Access Compliance Report

Public Rights-of-Way

Intersection ID: 27288	Main Street: PIPER_STATION_DR	Cross Street: REA_RD	Location: NW
ADA ID: 56DC99344763	Ramp Type: PerpDiag	Initial Pass/Fail: Fail	Overall Compliance: No
Severity Score: 35			
Codes/Mitigation Info/Possible Solution		Field Measurements/Component Compliance

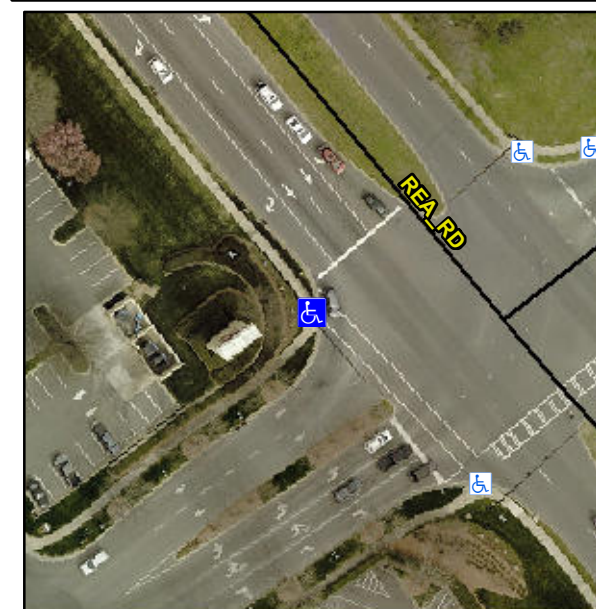
Not Found, R304.5.1, R304.2.2

Compliance	Description	Data	Compliance	Description	Data
N/A	Ramp Length (in)	68.0	No	Ramp Slope (%)	12.3
No	Ramp Width (in)	47.0	Yes	Ramp XSlope (%)	2.3
N/A	Flare Type LT	N/A	N/A	Flare Type RT	N/A
N/A	Flare Slope LT (%)	N/A	N/A	Flare Slope RT (%)	N/A
N/A	Flare Traversable LT?	N/A	N/A	Flare Traversable RT?	N/A
N/A	Landing Length (in)	N/A	N/A	DWS Provided?	N/A
N/A	Landing Width (in)	N/A	N/A	DWS Contrast?	N/A
N/A	Landing Slope (%)	N/A	N/A	DWS Length (in)	N/A
N/A	Landing X Slope (%)	N/A	N/A	DWS Full Width?	N/A
N/A	Landing Curb? (Y/N)	N/A	N/A	DWS Offset (in)	N/A
N/A	Shared Landing?	N/A			
N/A	Gutter Ponding?	N/A	N/A	Gutter Slope (%)	N/A
N/A	Gutter Lip Ht (in)	N/A	N/A	Gutter X Slope (%)	N/A
N/A	Painted X Walk1?	Yes	N/A	Painted X Walk2?	No
	X Walk 1 Direction	To SE		X Walk 2 Direction	To NE
N/A	X Walk 1 Width (in)	105.0	N/A	X Walk 2 Width (in)	N/A
	X Walk 1 Slope (%)	5.4		X Walk 2 Slope (%)	1.8
	X Walk 1 X Slope (%)	0.1		X Walk 2 X Slope (%)	4.9

Remove & Replace Curb Ramp With Two New Directional Ramps or Equivalent.
